Town of Franklin

Planning Board

September 28, 2020

DATE: September 23, 2020
TO: Franklin Planning Board
FROM: Department of Planning and Community Development
RE: Lakeview Terrace – Private Subdivision
Partial Form H

**Pharmacann Dispensary
SCL2 Series Lights
First Light Technologies Ltd.**

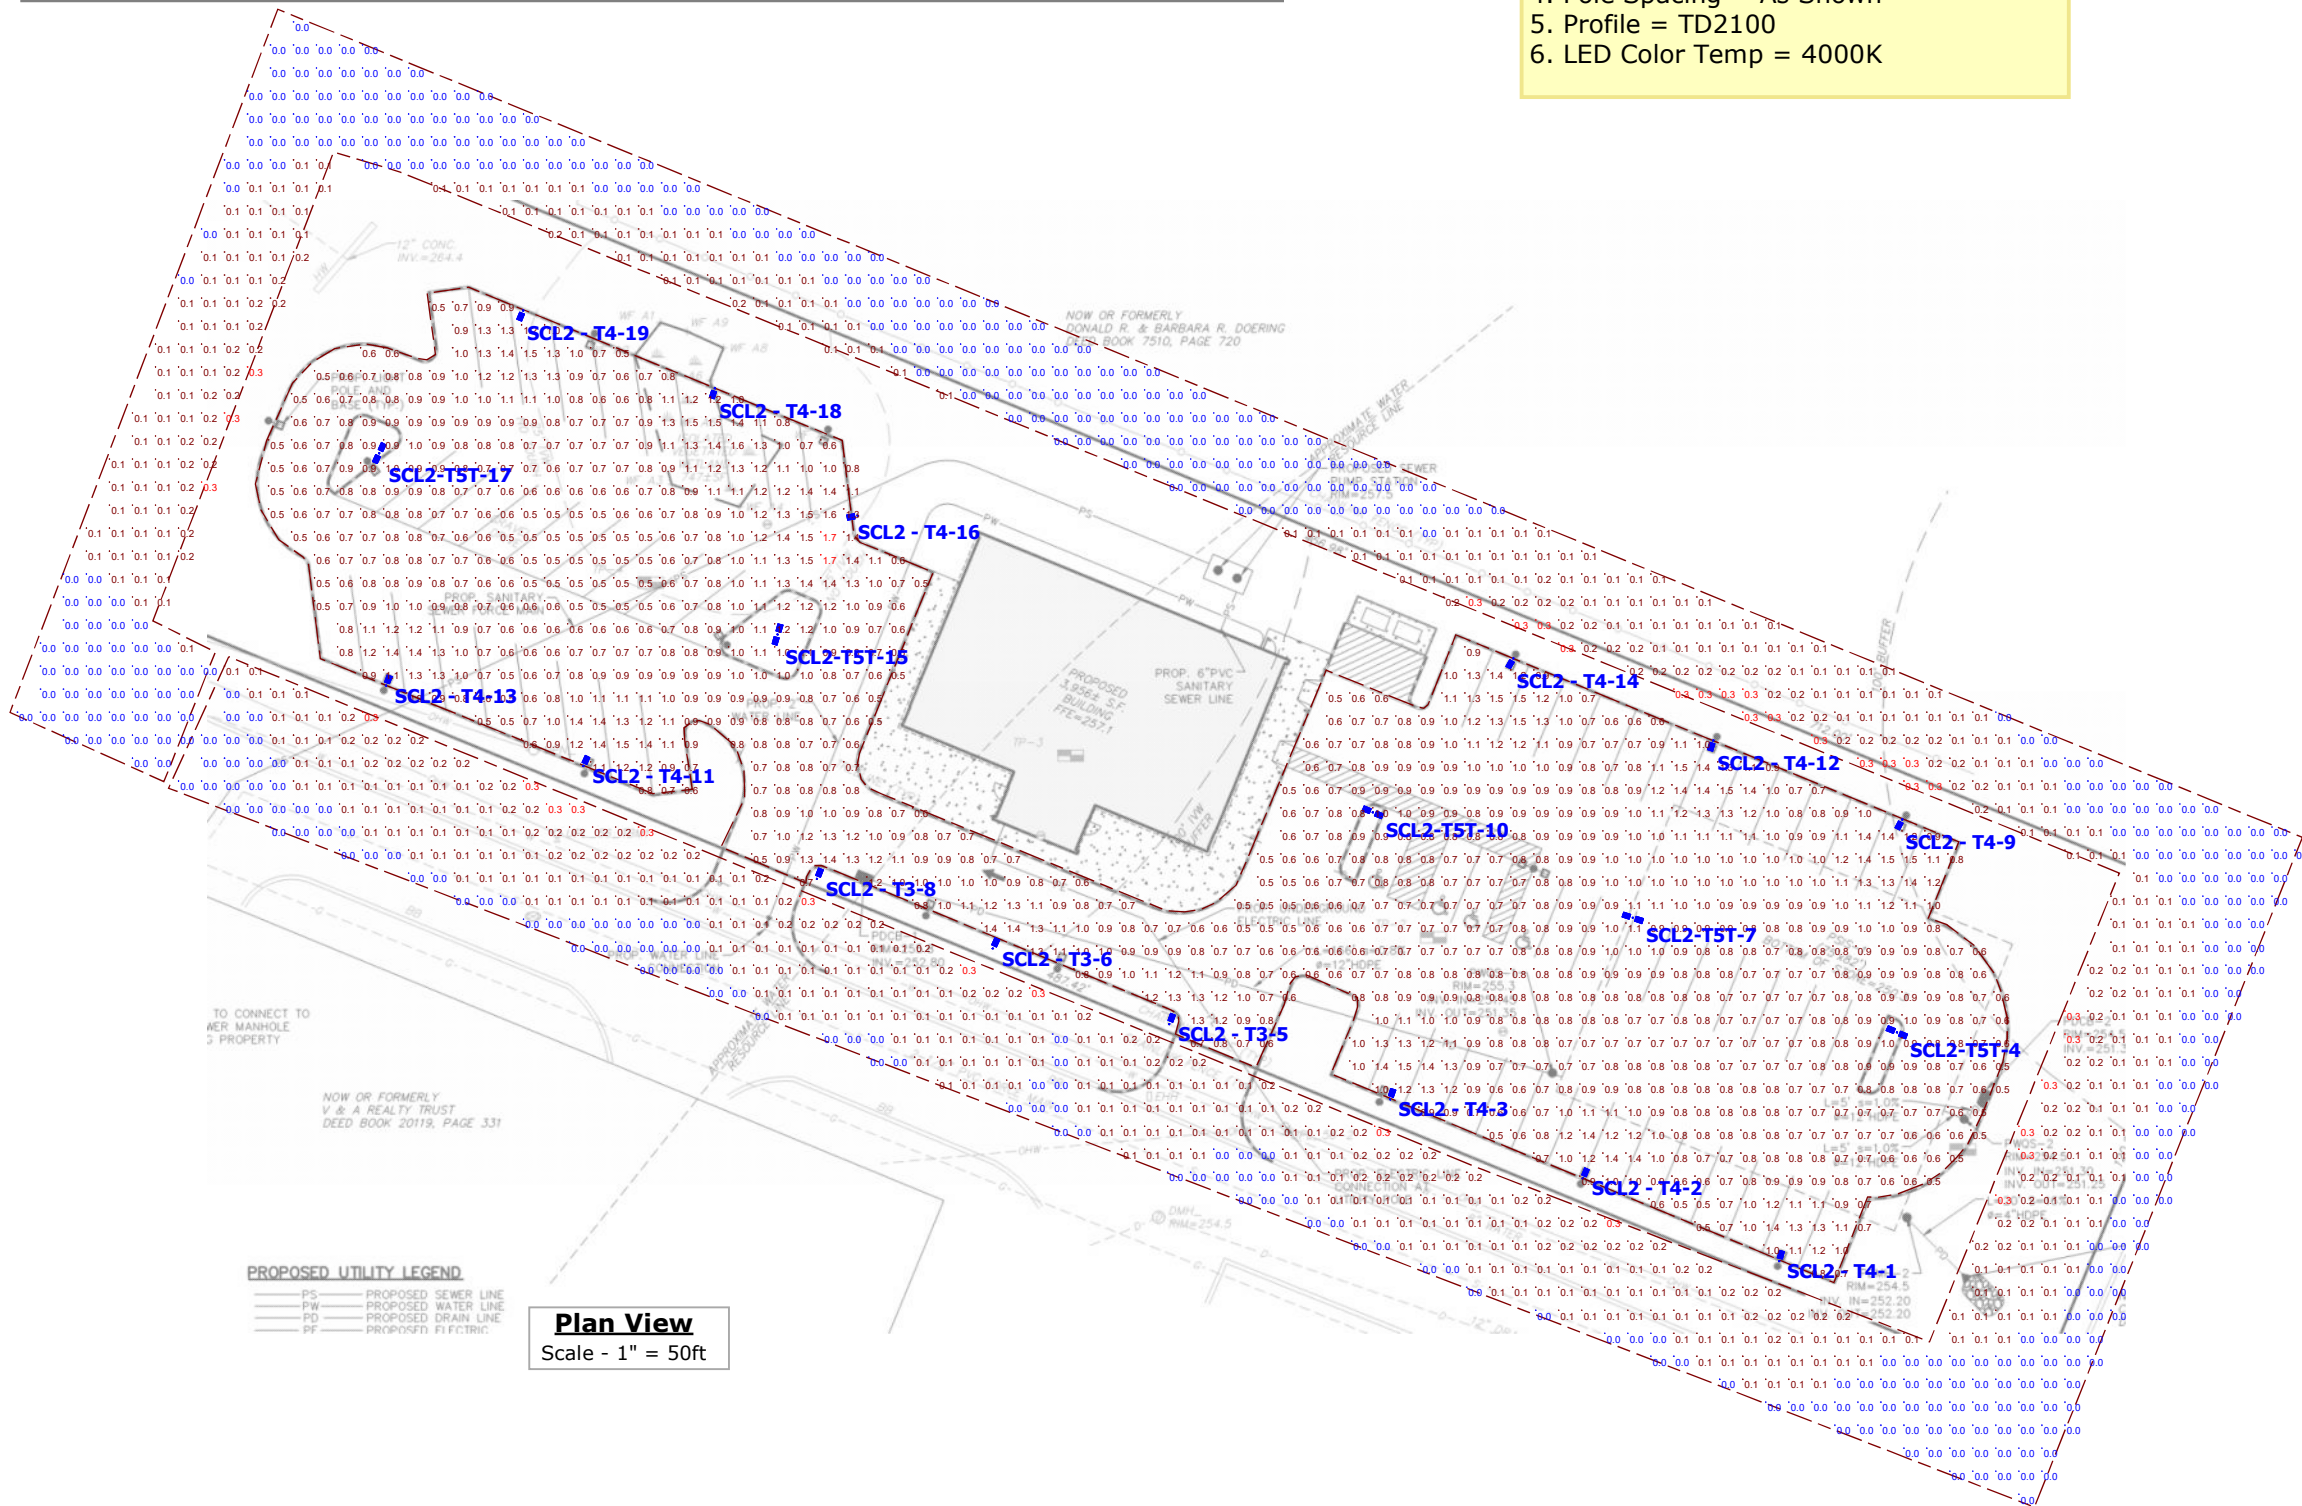
- S2. Provide photometric plan (§185-31.C.(3)(l)). *MAI: A photometric plan has been added to the plan set, refer to sheet 6.0.* **BETA2: Plan provided indicating adequate illumination will be provided for safety and security. Expand limits of analysis to demonstrate there will be no nuisance or excessive light spillage onto adjacent properties in accordance with site plan and special permit review criteria.** *MAI2: The photometric plan has been revised to expand the limits of the analysis to demonstrate there is no nuisance or excessive light spillage onto adjacent properties.* **BETA3: The revised plan indicates minor spillage on the order of 0.01 to 0.02 footcandles, the equivalent of moonlight, along portions of the northerly property line**
